Riverside in the Village
Building D - Essex Junction, VT
EPSC Plan

RE: Riverside in the Village
Site Plan Application – Building D / 11 Franklin St
Essex Junction, VT

To: Planning Commission
From: Robin Pierce, Community Development Director 
Date: October 17, 2019
Re: Riverside in the Village Building D/11 Franklin Street by O'Leary-Burke Civil Associates PLC, agent for 222 Franklin, Inc., owners

TYPICAL SIDEWALK SECTION

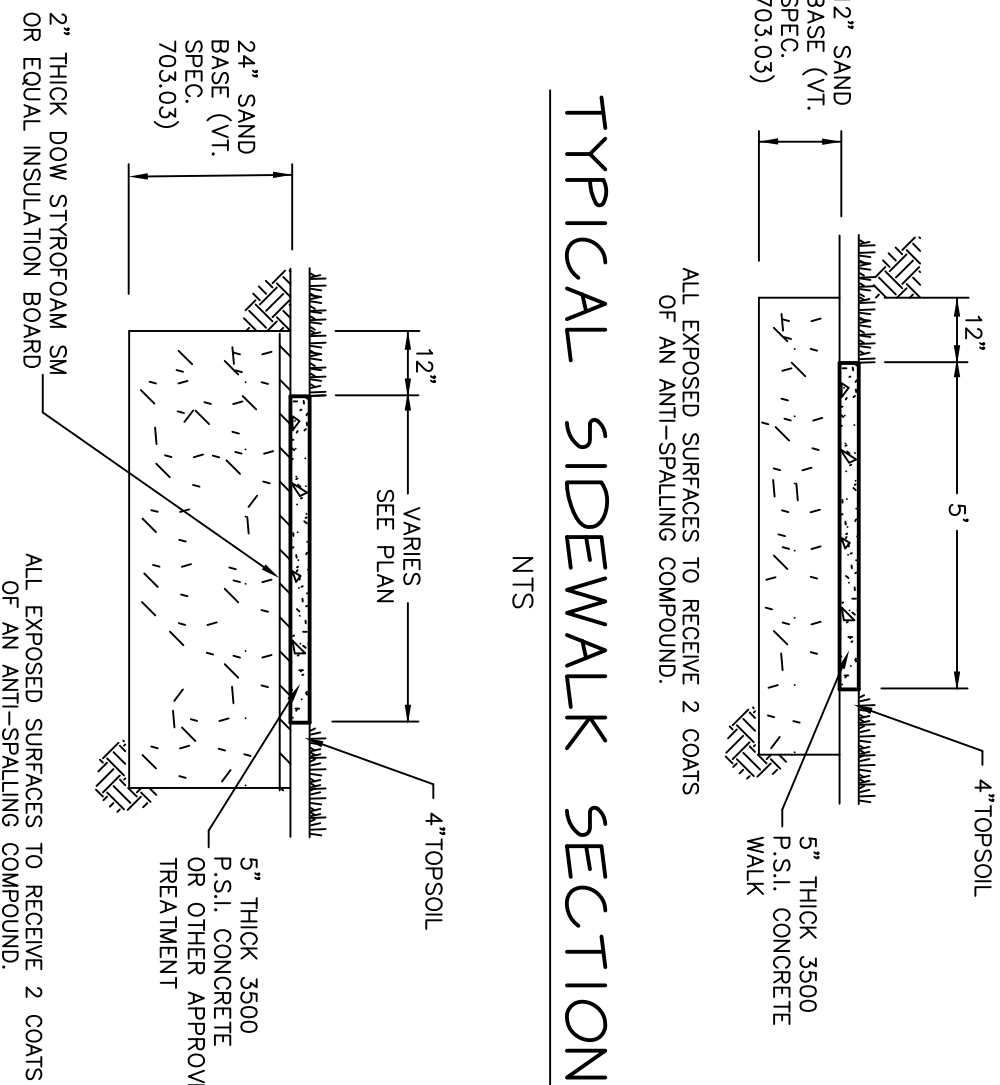
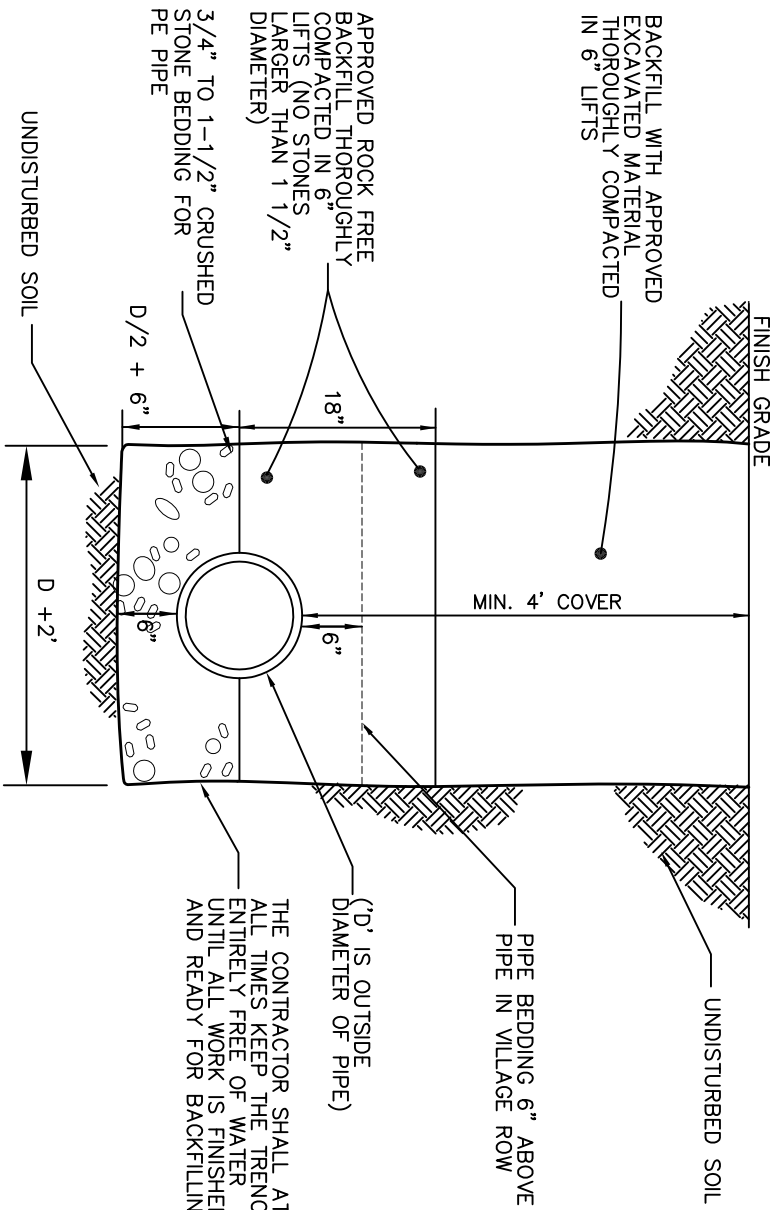
- 4) We note for the record that the sidewalk and curb details presented on Sheet #5 are not acceptable for use within the Village of Essex Junction right-of-way.

✓ **The applicant has indicated “Understood. The sidewalk and curbing details proposed will not be within a Village right-of-way.” No further comment necessary.**

EPSC Plan

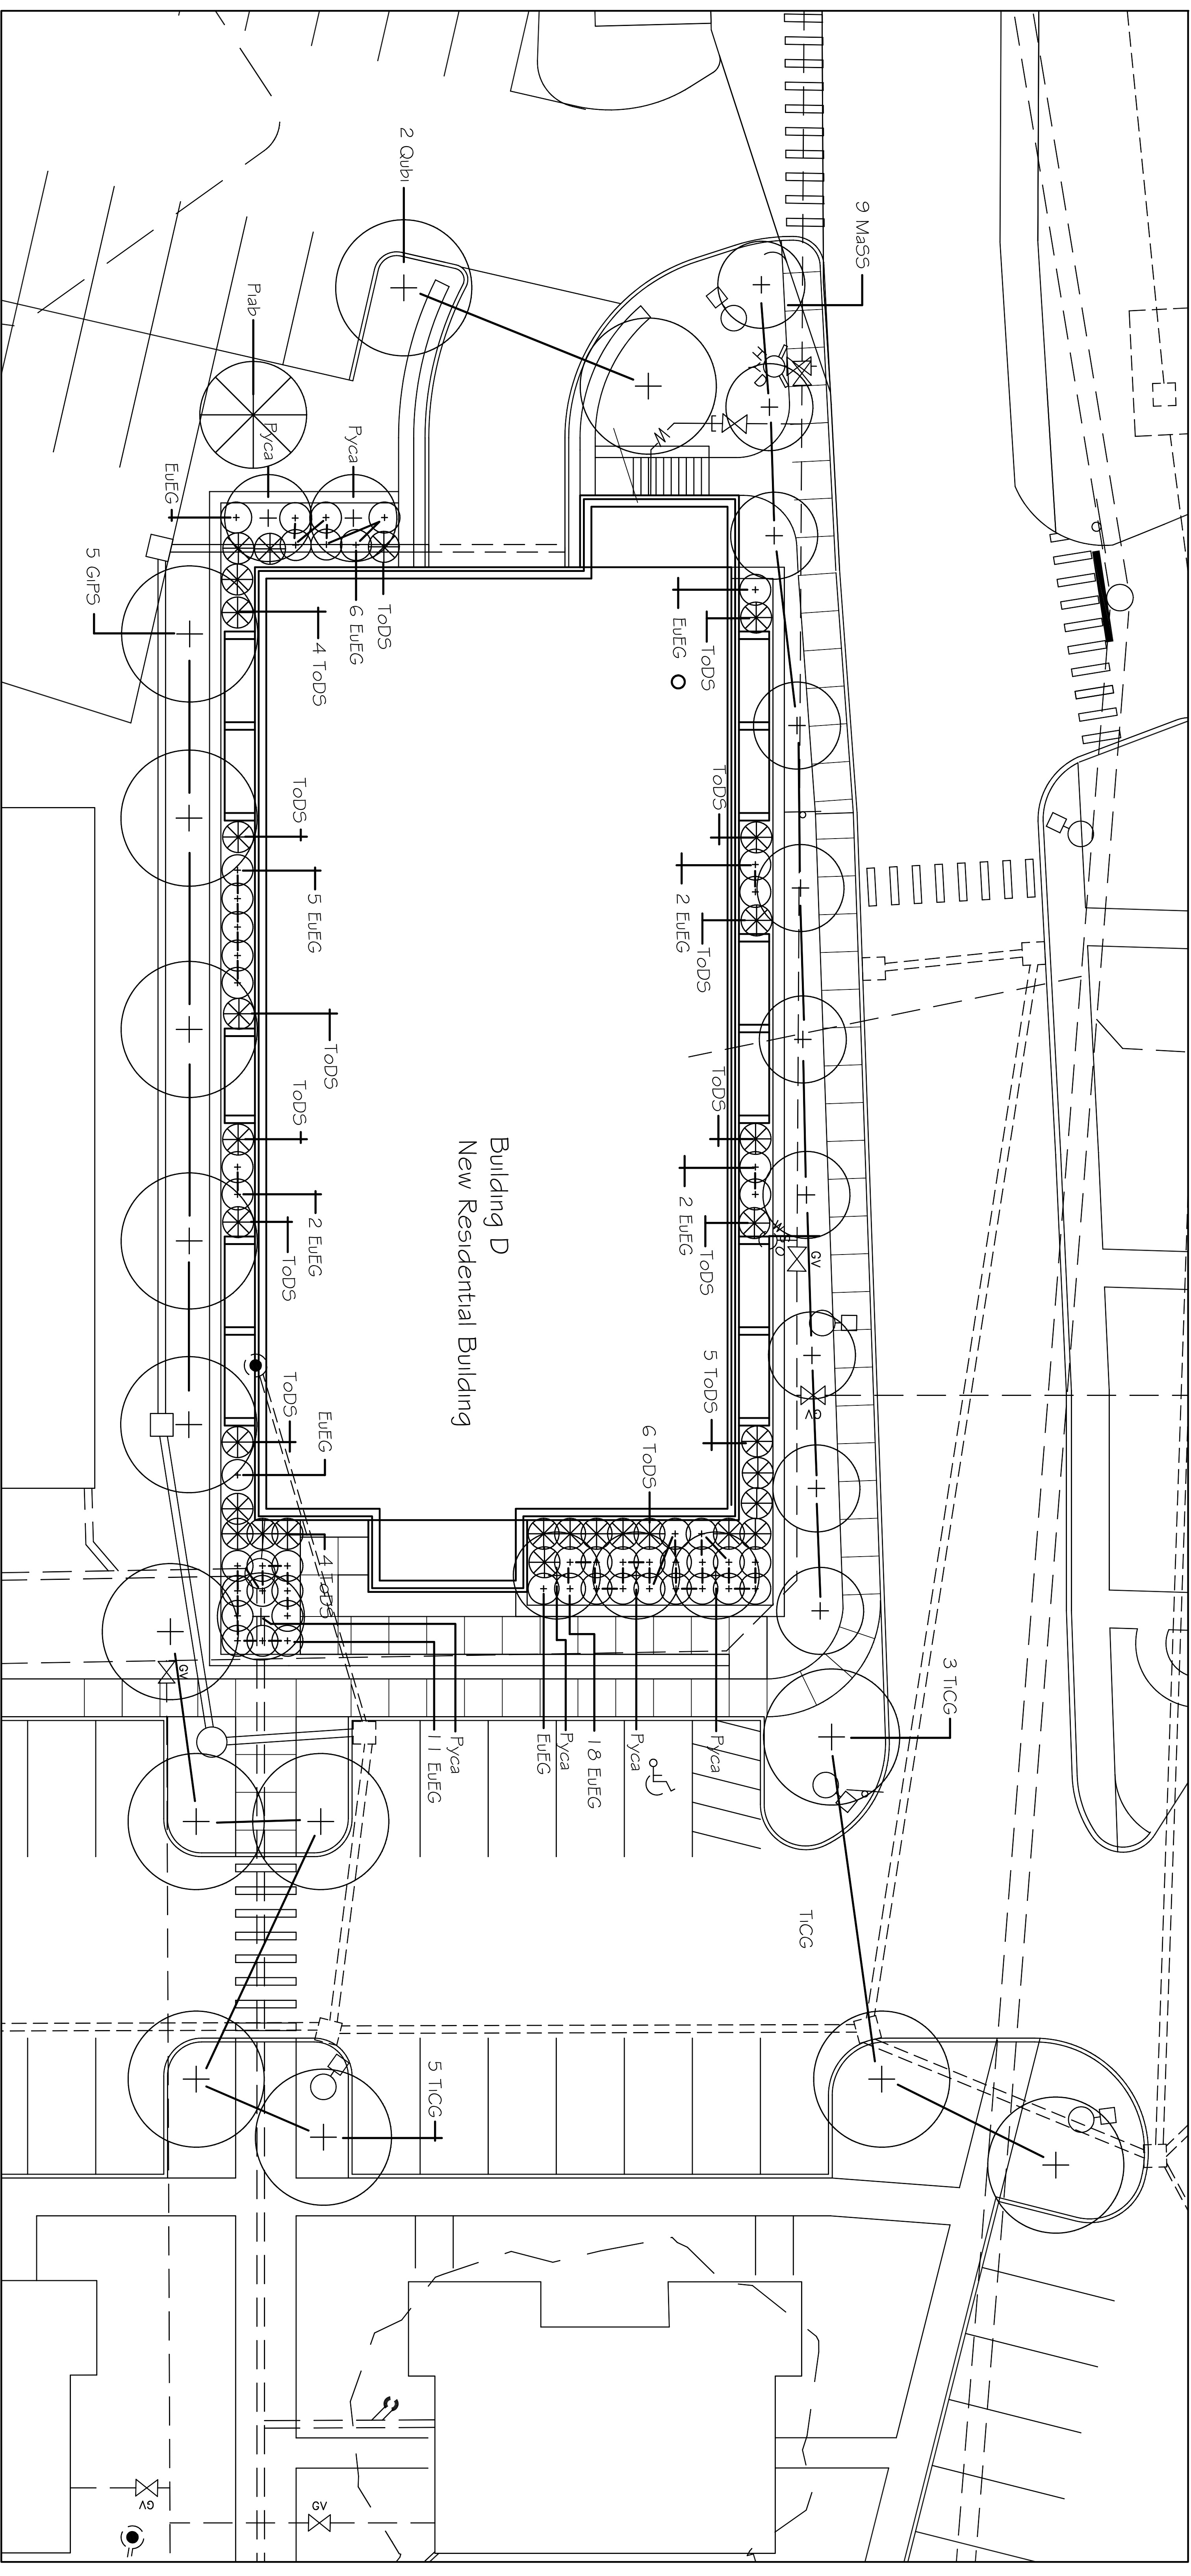
- 1) The EPSC Plan (Sheet #8) should be revised to include silt fence on the south end of the parking area located to the west of existing Building #5.
✓ **This comment has been addressed.**
- 2) The plans should be revised to require the use of non-Phosphorus based fertilizer unless otherwise warranted by soil testing. In addition, the plans should be revised to specify the seed mix(es) proposed for this project.
✓ **This comment has been addressed.**
- 3) The plans reference requirements for topsoil stockpiles surrounded by silt fence. The plans should be revised to depict the location(s) of proposed topsoil stockpiles.
✓ **The applicant has indicated that “It is likely that topsoil and other fill will be trucked off site due to the limited open space within the development.” We find this acceptable.**
